Bayside Planning Panel

Item No	6.8
Application Type	Development Application
Application Number	DA-2009/316/D
Lodgement Date	22 September 2017
Property	52 Clareville Avenue, Sandringham NSW 2219
Owner	Mrs Anastasia Susan Prapas and Mr Jim Prapas
Applicant	Mr Jim Prapas
Proposal	S96 (1A) Modification Application seeking to reduce lift overrun height, relocation of lift door to east side, addition of a colorbond roof to roof terrace and deletion of Condition 11a
No. of Submissions	Three (3)
Cost of Development	N/A
Report by	Adam Iskander – Development Assessment Planner

Section 96(1A) – Delegated Report

Application Number: DA-2009/316/D
Date of Receipt: 22-Sep-2017
Property: 52 Clareville Avenue, SANDRINGHAM NSW 2219
Lot 13 DP 5643
Owner: Mr J Prapas and Mrs A S Prapas
Applicant: Mr J Prapas
Proposal: S96 (1A) Modification Application seeking to reduce lift overrun height, relocation of lift door to east side, addition of a colorbond roof to roof terrace and deletion of Condition 11a

Shadows Winter Solstice
3pm
1 : 200

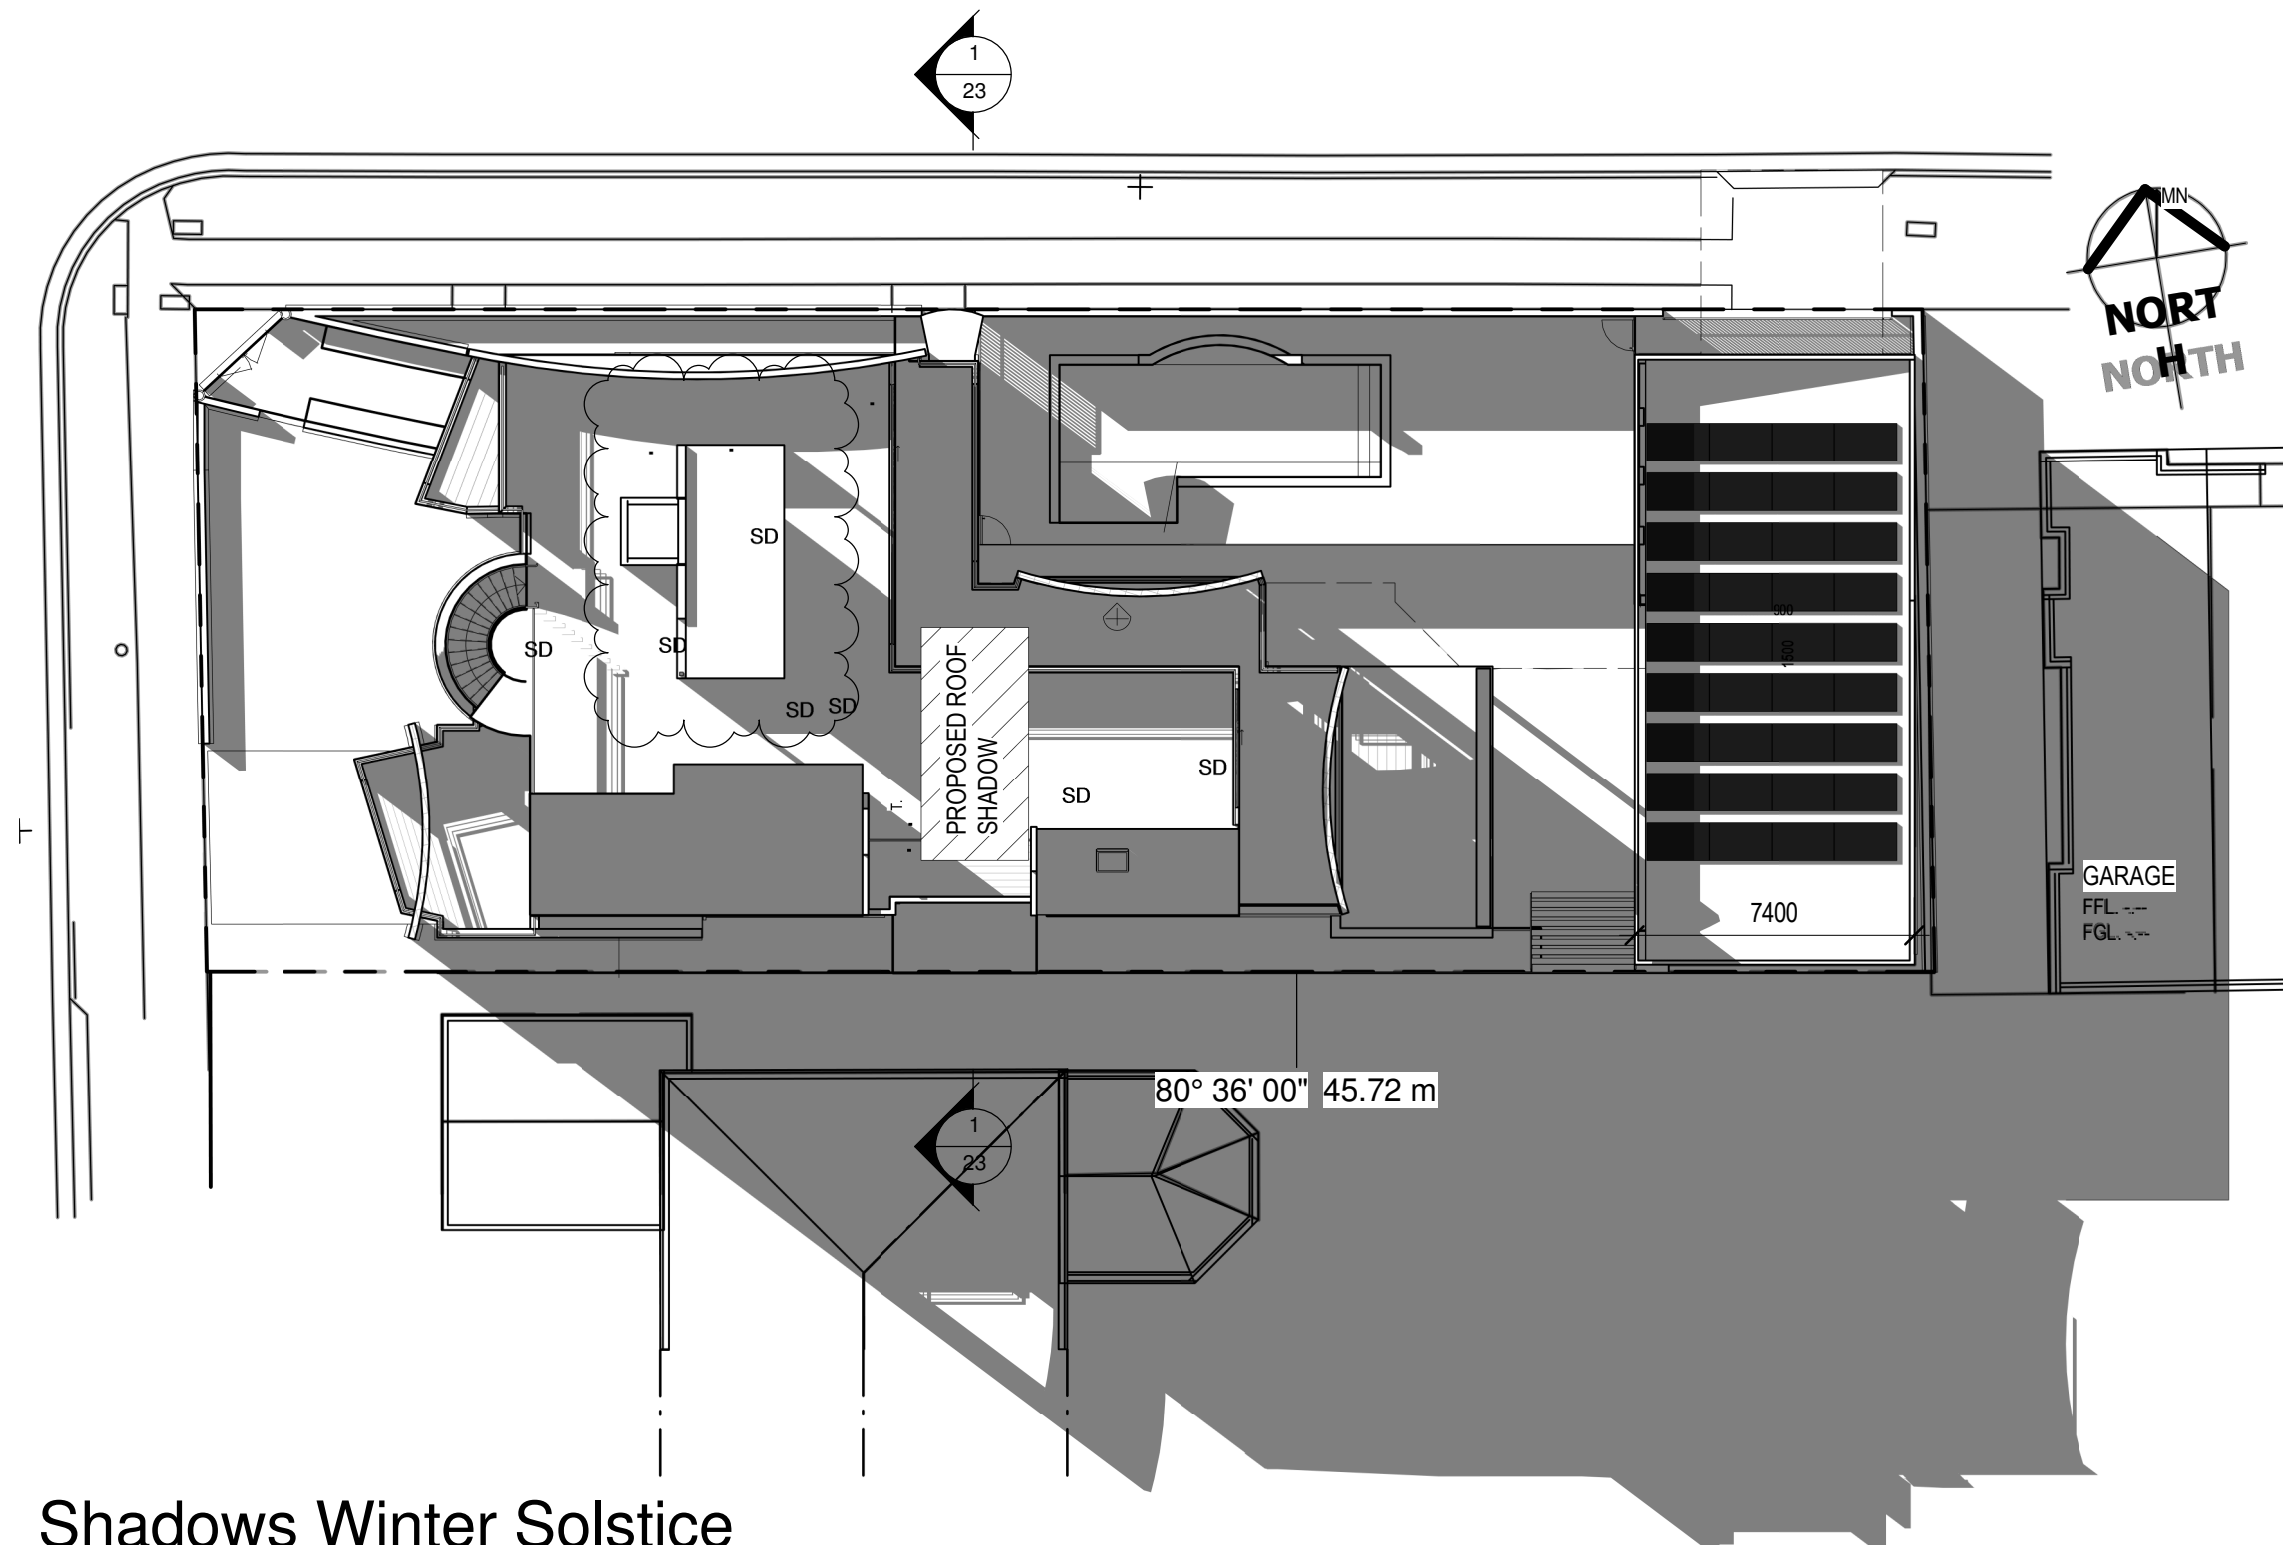
According to the submitted shadow diagrams, the shadows created by the roof top entry point will not cast beyond the building edge, therefore, there will be no additional over-shadowing onto the southern neighbour. The application satisfies Objective B of Part 4.4.2 of RDCP where the proposed works do not unreasonably diminish sunlight to neighbouring properties.

Issue: Insufficient information on the impacts of solar access in mid-summer;

Comment: Council is satisfied with the shadow diagrams provided. The shadows created by the proposed covered area in front of the lift will not cast beyond the building edge, therefore, there will be no additional over-shadowing onto the southern neighbour. The application satisfies Objective B of Part 4.4.2 of RDCP where the proposed works do not unreasonably diminish sunlight to neighbouring properties.
